Rezoning Transportation Analysis

Petition Number: 2019-174

Revision Log:

Date	Description
01-14-2020	First Review-MTH
02-17-2020	Second Review

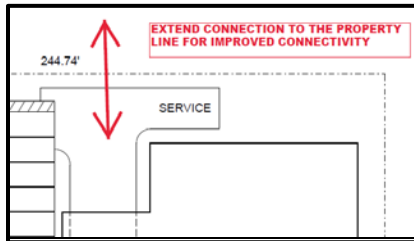
1. **Curbline** The proposed zoning district has a setback measured from back of the existing or proposed future curbline.
 - a. **Colsgate Road:** The future location of curb and gutter is in its existing location.

The site plan should show the curb and gutter labeled and dimensioned from the centerline for each road.

Technical Correction based on site plan 02/10/2020: Petitioner is showing dimension from C/L to what appears to be edge of pavement, please updated to dimension existing back of curb.
